Access Compliance Report

Public Rights-of-Way

(Curb Ramps)

Intersection ID: 14070	Main Street: HARRISBURG_RD	Cross Street: PENCE_RD	Location: SE
ADA ID: F19AFF4A7200	Ramp Type: Para	Initial Pass/Fail: Fail	Overall Compliance: No
Codes/Mitigation Info/Possible Solution		Field Measurements/Component Compliance	
Severity Score: 13.75

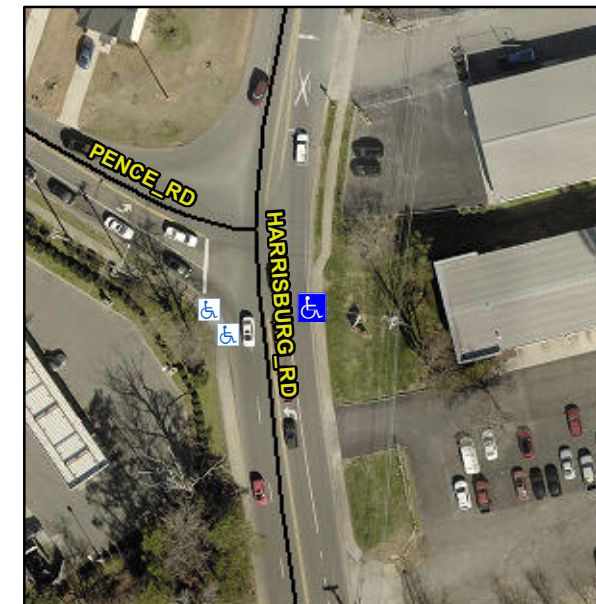
RT RP < 5%

R304.3.2, R304.5.3

Compliance	Description	Data	Compliance	Description	Data
N/A	Ramp Length LT (in)	71.5	N/A	Ramp Length RT (in)	69.5
Yes	Ramp Width LT (in)	60.5	Yes	Ramp Width RT (in)	60.0
No	Ramp Slope LT (%)	8.4	Yes	Ramp Slope RT (%)	2.7
No	Ramp XSlope LT (%)	3.0	No	Ramp XSlope RT (%)	3.3
N/A	Landing Length (in)	N/A	N/A	DWS Provided?	N/A
N/A	Landing Width (in)	N/A	N/A	DWS Contrast?	N/A
N/A	Landing Slope (%)	N/A	N/A	DWS Length (in)	N/A
N/A	Landing X Slope (%)	N/A	N/A	DWS Full Width?	N/A
N/A	Landing Curb? (Y/N)	N/A	N/A	DWS Offset (in)	N/A
N/A	Shared Landing?	N/A			
N/A	Gutter Ponding?	N/A	N/A	Gutter Slope (%)	N/A
N/A	Gutter Lip Ht (in)	N/A	N/A	Gutter X Slope (%)	N/A
N/A	Painted X Walk1?	No	N/A	Painted X Walk2?	N/A
	X Walk 1 Direction	To W		X Walk 2 Direction	N/A
N/A	X Walk 1 Width (in)	N/A	N/A	X Walk 2 Width (in)	N/A
	X Walk 1 Slope (%)	3.6		X Walk 2 Slope (%)	N/A
	X Walk 1 X Slope (%)	4.0		X Walk 2 X Slope (%)	N/A
N/A	Ramp inside XWalk1?	N/A	N/A	Ramp inside XWalk2?	N/A

Remove & Replace Entire Ramp.
